REPORT AMENDED BY CPC 10-12-89
CITY PLANNING COMMISSION

- APPLICATION:**
- A. Negative Declaration
 - B. Tentative Map to divide 6.7 partially developed acres into 38 standard single family lots in the Standard Single Family (R-1) Zone.
 - C. Variance to reduce the minimum lot depth (withdrawn)
 - D. Subdivision Modification to reduce lot depth (withdrawn)

LOCATION: Northeast Corner of Bellview Avenue and Lemon Hill Avenue

TENTATIVE SUBDIVISION MAP BELLEVIEW ESTATES CITY OF SACRAMENTO JANUARY 1989

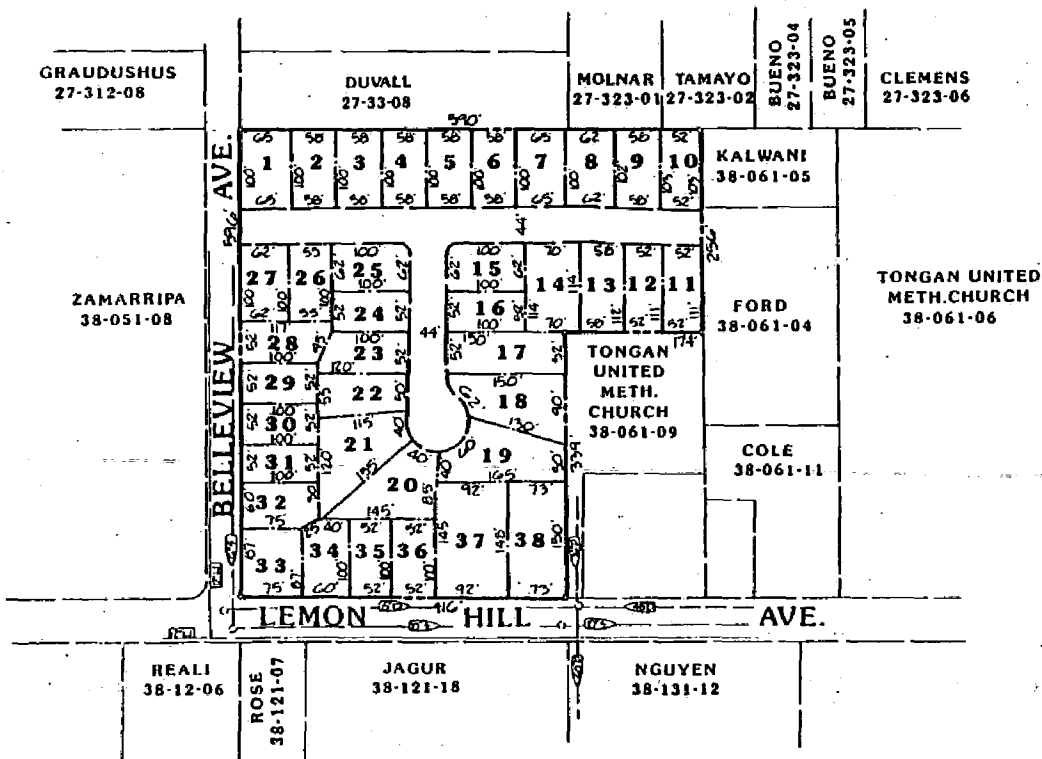
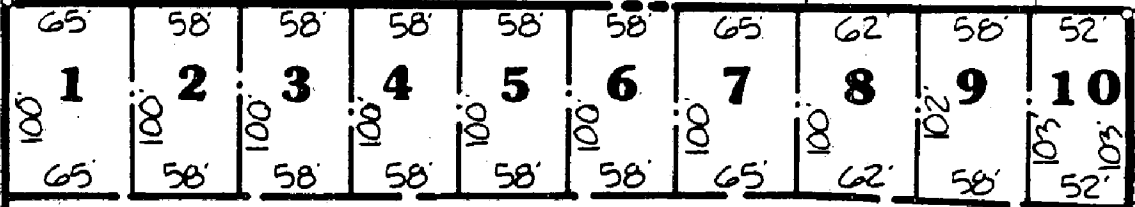
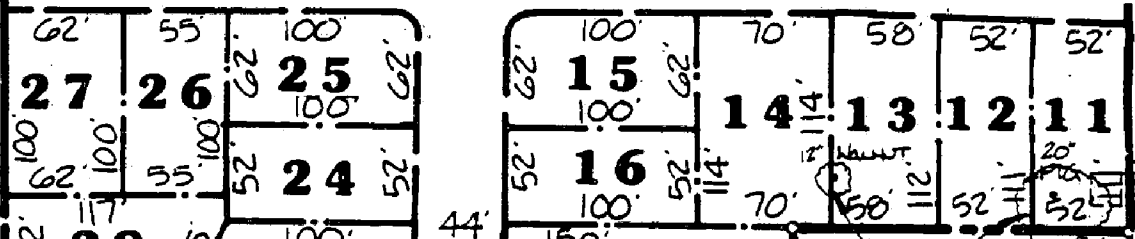
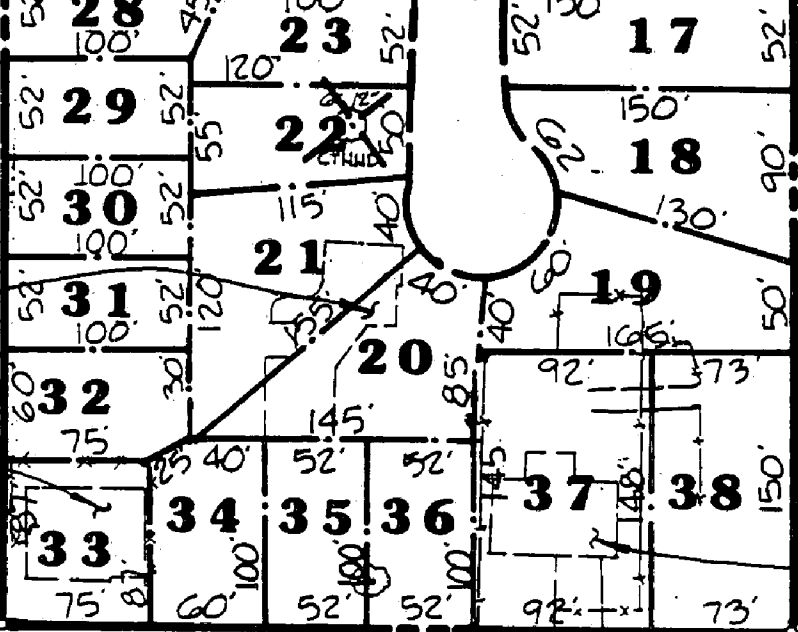
Staff notes that the existing single family dwellings are not shown on the original tentative map. Staff recommends that if the two dwellings are to be retained, that the proposed property lines observe all required setbacks. The final map shall show the existing structures complying with the minimum setbacks of the R-1 Zone.

Staff has noted that a storm drain line easement bisects the site. Lots 14 and 7 and 8 may require redesign to allow for the storm drain easement.

The proposed east-west street off Bellview should have a turning area at the east property line. Staff recommends that the applicant show a turning area approved by the City Traffic Engineer and Fire Marshall's Office.

Three lots fronting on Lemon Hill are 100 feet in depth with two lots 145 feet deep. Staff recommends the lots along Lemon Hill be increased to a minimum of 125 feet of depth and an increased front yard setback established at 35 feet rather than the standard 25 feet. The increased setback would provide a larger front yard commonly found in the area. Lot width should be increased to a minimum width of 60+ feet which is less than the 75 foot development standards along major streets stated in the 1986 South Sacramento Community Plan.

In reviewing the tentative map design, staff observes the mix of lot dimensions makes for several oddly shaped parcels. Staff recommends that the applicant redesign the tentative map to show more standard parcels reflecting easements, buildings to be preserved, and standard size lots on the interior and lots 125 feet deep and 58+ feet in width fronting on Lemon Hill.

On the original tentative map, Lot 33 did not meet the minimum lot depth requirement for a corner lot of 100 feet. Since a single family dwelling is located on the lot, staff recommends the tentative map be revised to show all structures, including the two houses with minimum setbacks. Lots fronting on Lemon Hill Avenue are recommended to have 125 feet of lot depth in order to provide a larger front yard area. Staff does not support the variance or subdivision modification. The map can be redesigned to allow larger lots which would be more appropriate in this area of the City where larger lots are prevalent.

14. Place flood hazard warning note on final map, if required. Note will be provided by Department of Public Works;
15. Revise the lots along Lemon Hill to be a minimum of 60+ ft. in width and 125 feet in depth. A minimum 35 foot front yard setback shall be recorded for all lots fronting on Lemon Hill;

16. Future property lines shall observe the minimum required setbacks from all existing structures. The final map shall show existing structures and dimensions to all property lines;

18. Show all existing storm drain locations and existing ditches on the final map;
19. Show Bellview with a 50 ft. R/W (25' half-section) and standard round corner on lots 1, 27, and 33;

20. Preserve trees as shown on the tentative map;
21. Provide a temporary turning area at the eastern end of the proposed east-west street off Bellview to the satisfaction of City Traffic Engineer;

DRAFT
 REVISED TENTATIVE
 MAP 7-26-89
 BELLEVIEW ESTATES.

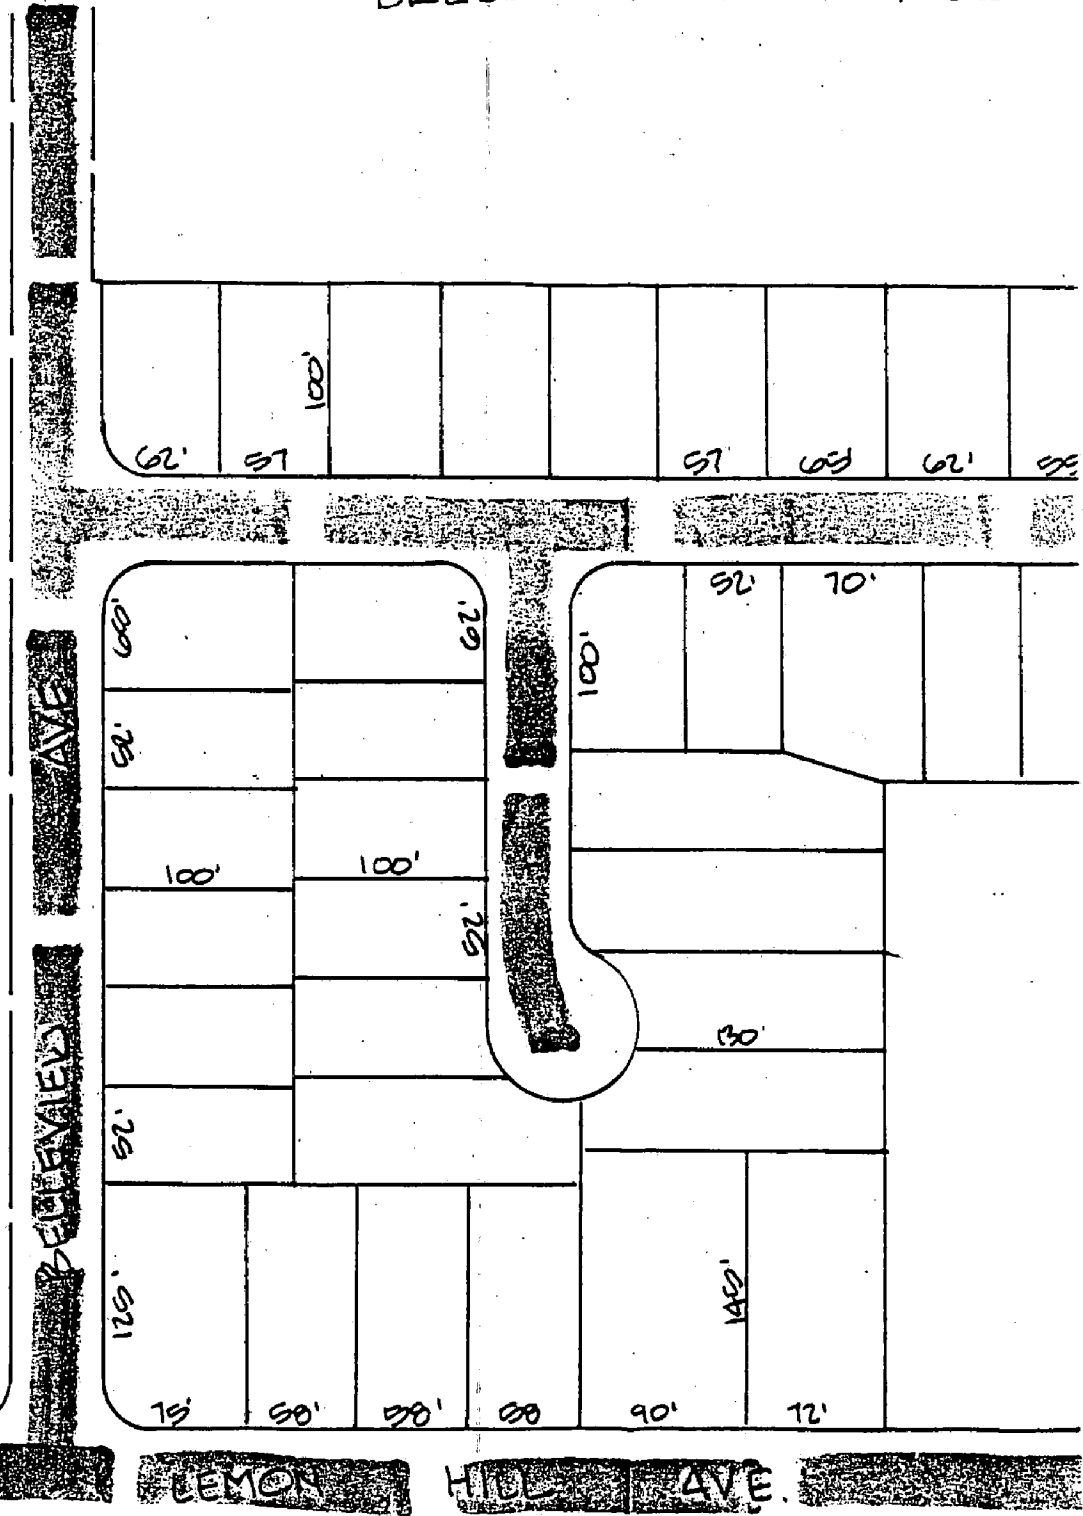
The applicant provided a revised map at the July 26, 1989, Subdivision Review Committee meeting which increased the lot depth of parcels fronting on Lemon Hill from 100 feet to 125 feet. Specific setbacks from the proposed property lines to be existing dwellings were not shown. Staff recommends that actual property lines reflect minimum building setbacks.

Staff has not reviewed building plot plans for lots along Lemon Hill Avenue where a 35 foot front setback will be established. In the front yard area, only 40 percent of the total required front yard area can be covered with impervious surfaces. Staff recommends the Planning Director review and approve all plot plans for lots fronting on Lemon Hill for compliance with setbacks, hammerhead driveway design, lot coverage, and landscaping prior to issuance of building permits. A note to this effect shall be recorded in the deeds fronting on Lemon Hill.

17. For vacant lots fronting on Lemon Hill, within the 35 foot front yard setback, a hammerhead driveway turning area shall be provided with decorative treatment such as turfstone subject to Planning staff review. Front yard landscaping shall include shrubbery between the sidewalk and turning area. All front yards are to be landscaped fronting on Bellview Avenue or Lemon Hill Avenue;

DRAFT
 REVISED TENTATIVE
 MAP 7-26-89
 BELLEVIEW ESTATES

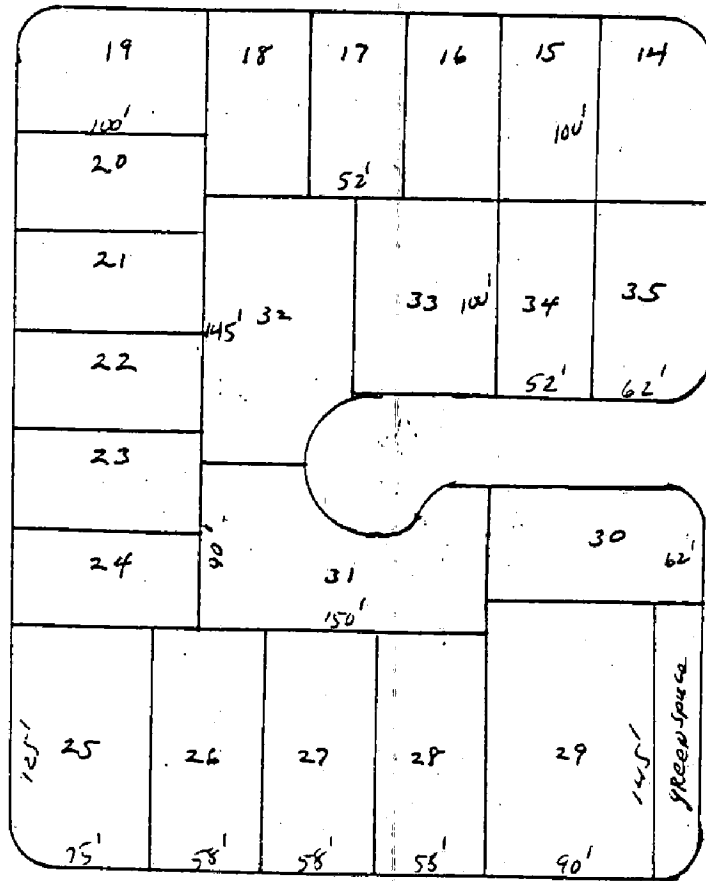
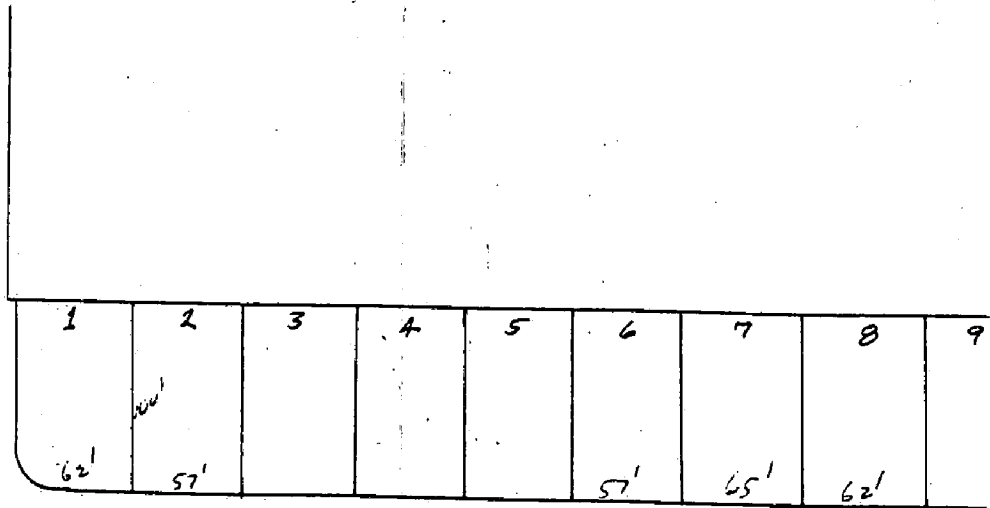
2. There is a large **400 foot open drainage ditch** between my property and the development. This is the northern boundary of the development. It is not mentioned or considered on any of the present plans. I can see why on environmental impacts there was a negative declaration, when important concerns are not mentioned. This storm drain ditch **not mentioned in the commission report** drains my personal property so it is not a swamp. But more importantly it is the **PRIMARY STORM DRAIN** for the entire street of Bellview Ave. It empties into the 3 foot concrete storm drain easement that was mentioned as bisecting the development property. The existing residents and new residents **NEED ASSURANCES** that **this drainage will not be impeded,** if anything is done it should be improved.

Belleview can just barely handle the present automobile traffic. Fact, there are at least 30 new homes presently being constructed further north on Belleview. This will increase traffic by at least 30%. The tentative plan before you diverts all its new traffic on to Belleview, another 30+% increase in traffic. The present residents on Belleview want a **SECONDARY ACCESS TO THE DEVELOPMENT**, now and not in some imaginary future. This will **reduce the hazards** presented by the automobiles on this street which after construction will for the most part still be a rural road, not quit large enough in places for two cars to pass without driving off the pavement. There are plans here to line the pockets of developers but not enough planning to resolve all the down stream problems for the community. Mr. Johnson said he was good at planning and could do just about anything to meet needs. I believe him and ask why a second access to Lemon Hill is not possible? I have provided some quickly sketched possible solutions Exhibit #1 & #2. I am sure they could be manipulated by a good planner to maximize benefits.

A foot note here is that a turnaround at the end of the new development street still is not shown on the plans. And it seems to me that a secondary access to this development would greatly **improve the access to city/county safety, fire, police and maintenance equipment.**

4. The other major concern is with the development fitting in to the existing neighborhood. Present property fronts are on average 100 feet. We are requesting that those properties fronting on Belleview be **MORE APPROPRIATELY SIZED** to blend into the neighborhood rather than stick out, as is exemplified on Exhibit #1 (approx. 80 foot fronts).
